**EPC STORMWATER REVIEW COMMENTS  
IN ORANGE BOXES WITH BLACK TEXT**

**SMALL SUBDIVISION FINAL DRAINAGE REPORT  
FOR  
CLOVERLEAF FILING NO. 1**

**Project No. 25158.01**

**Add text:  
PCD Filing No.: SF-21-014**

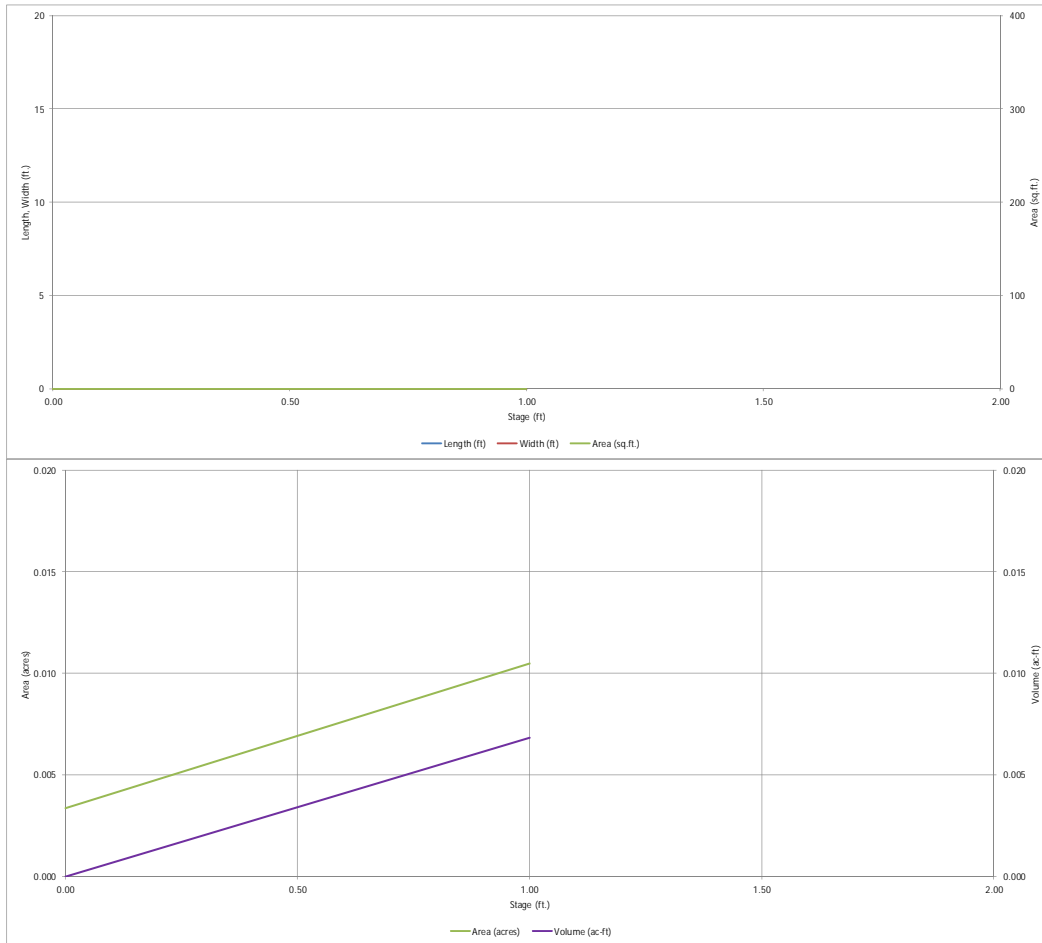
If applicable, input the overflow domed grate and 4" outlet pipe calcs into this sheet so all calcs are in one place.

This sheet was revised to include a full-spectrum design. Please note the drain time was limited by the required orifice diameter per your comment on the proposed drainage map.

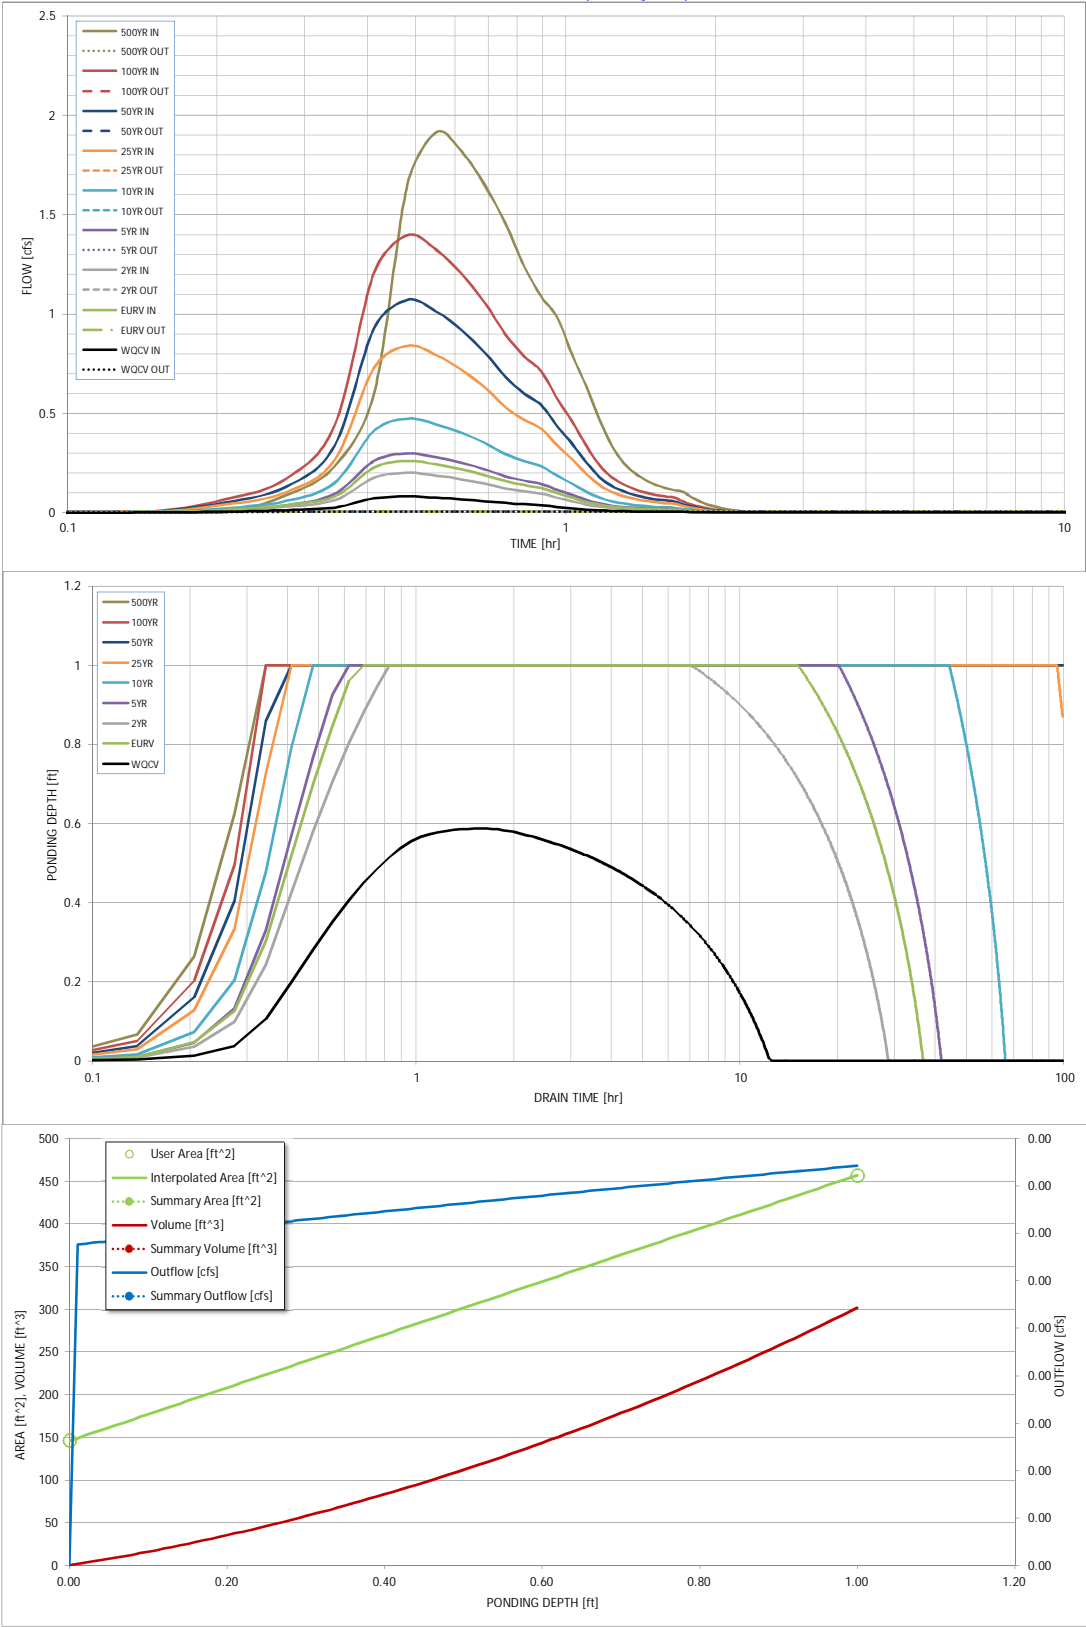
Complete this section and revise detail on plans if necessary.

At depth of 1ft, the overflow grate (not filtration media) would be utilized up to 100-yr storm (according to calcs on page 49) and then the spillway for the 500yr. Revise accordingly for each SF.

From EURV to 500-yr storm, there is not much detention happening since the overflow grate is being utilized. For these storms, the inflow should almost equal the outflow. Meaning that the Peak Outflow for these storms should be greater than 0.0. Please revise.

Addressed

Addressed, all storms were designed to be as close to a 1:1 pre-dev inflow versus outflow ratio as possible

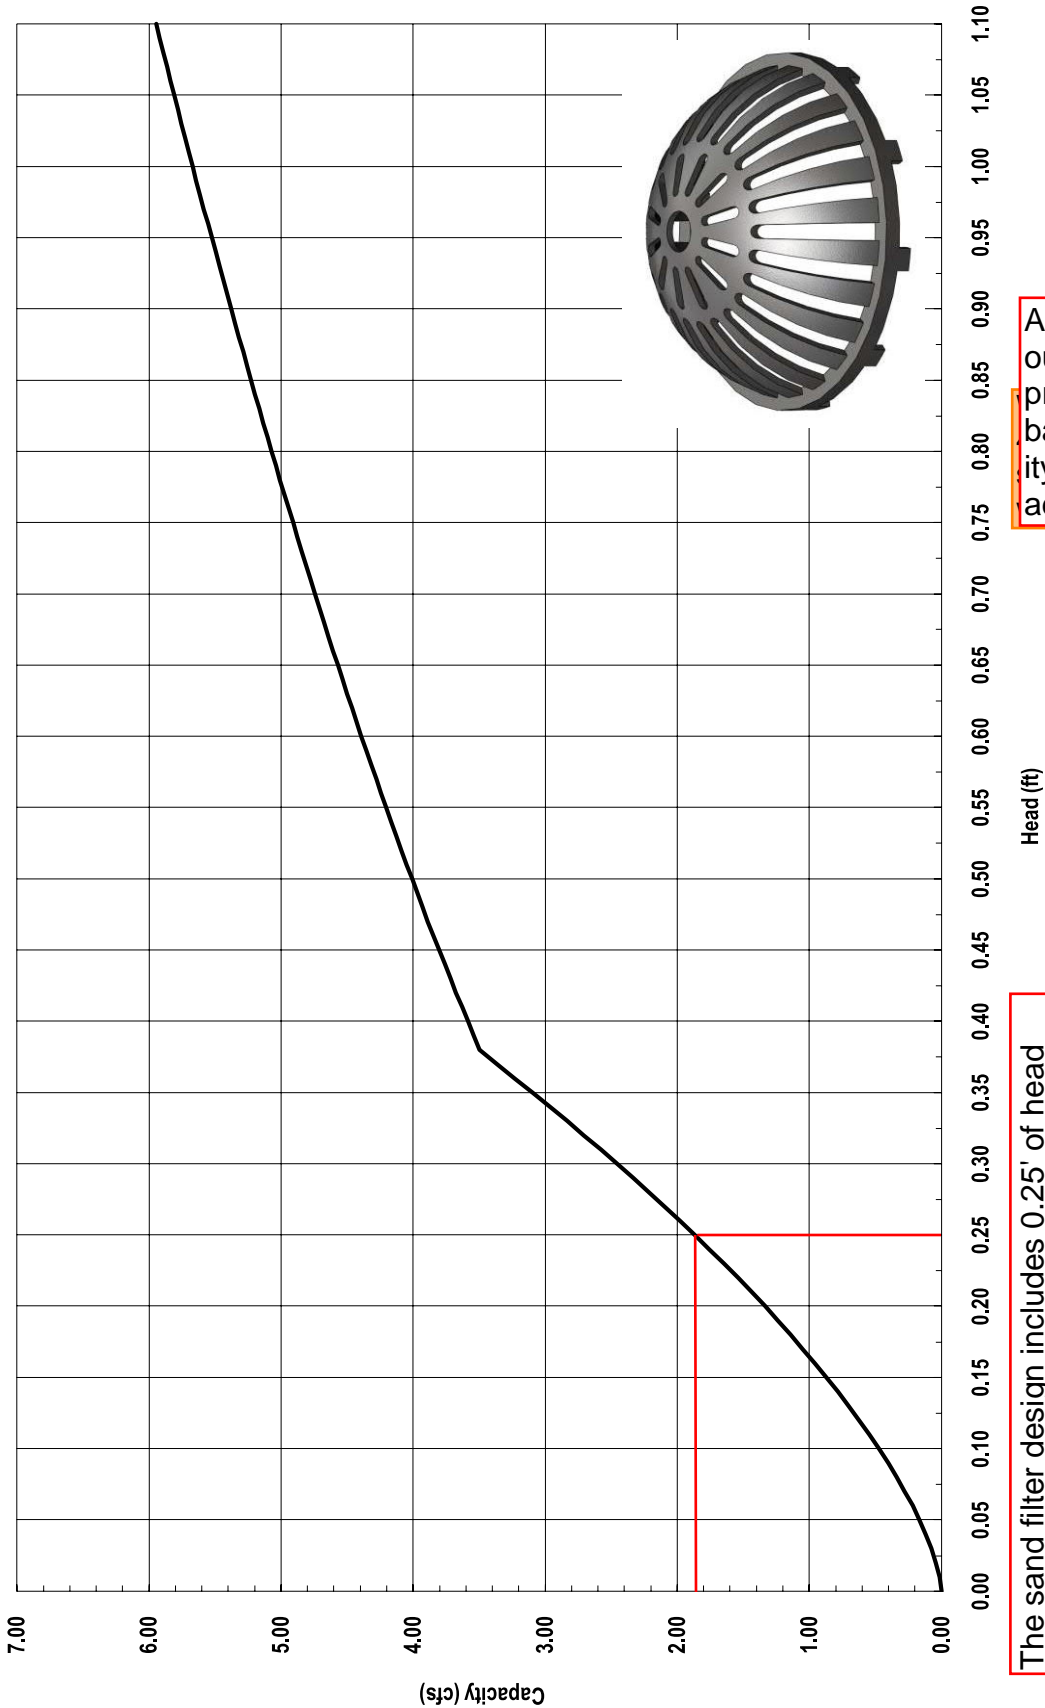
Also include the invert of all outlets (e.g. vertical orifice, overflow grate, and spillway, where applicable).

Also include the inverts of all outlets (e.g. vertical orifice, overflow grate, and spillway, where applicable).

Addressed, a 12" outlet pipe is now proposed for each basin and a capacity calc has been added.
